UNITED STATES
NUCLEAR REGULATORY COMMISSION
WASHINGTON, D. C. 20555

Docket No. 50-29

Subject: Reportable Occurrence 50-29/77-30/01T
Errors in Accident Analysis

SUMMARY OF MEETING HELD ON JUNE 17, 1977, FOR BRIEFING ON MATTERS RELATING TO ECCS PERFORMANCE EVALUATION FOR YANKEE-ROWE

PRESENT SAFETY INJECTION SYSTEM

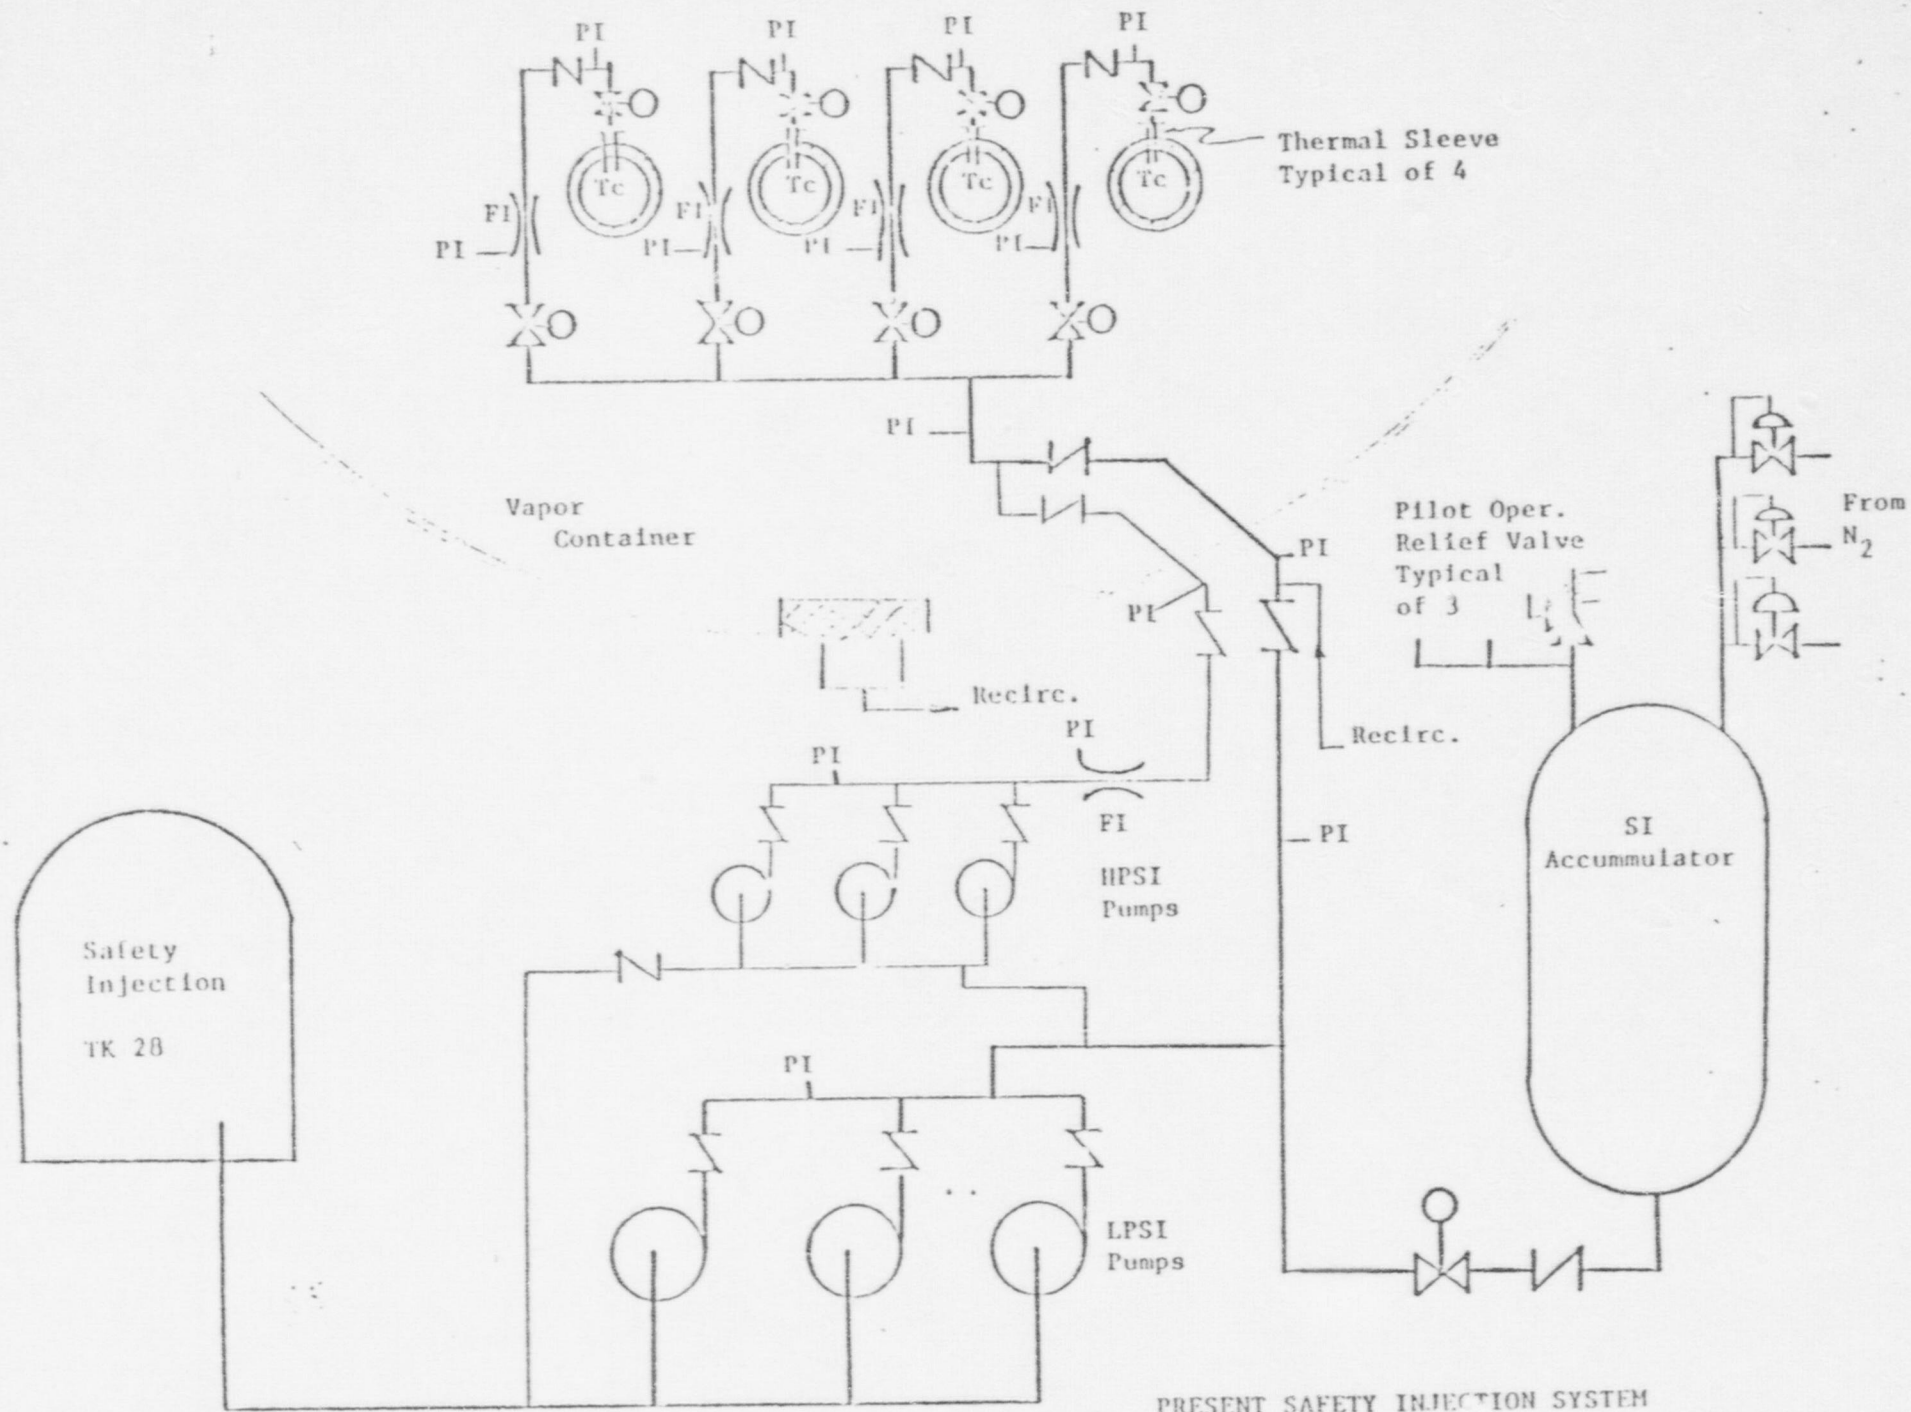
With regard to YAEC's proposal to reinstate power to the motor operated valves in the safety injection lines to permit valve closure for preserving accumulator inventory, the staff commented that considerable support would have to be provided to justify operator action (to identify and isolate the broken line). The staff suggested that as an alternative to relying on operator action, YAEC should give thorough consideration to flow balancing by changing the flow resistances as necessary so that the system flows would more closely match the ECCS performance that had previously been considered acceptable.

At the conclusion of the meeting YAEC withdrew its initial proposal to reinstate power to the motor operated valves in the safety injection lines and committed to the following actions for obtaining NRC approval for operation of Yankee-Rowe with Core XIII.

- To provide the increased permanent flow resistances in each safety injection line by replacement of the 4 inch check valves with a 2 1/2 inch check valve or by other appropriate means as determined to be suitable and practical. Provide descriptions and bases for the modifications.
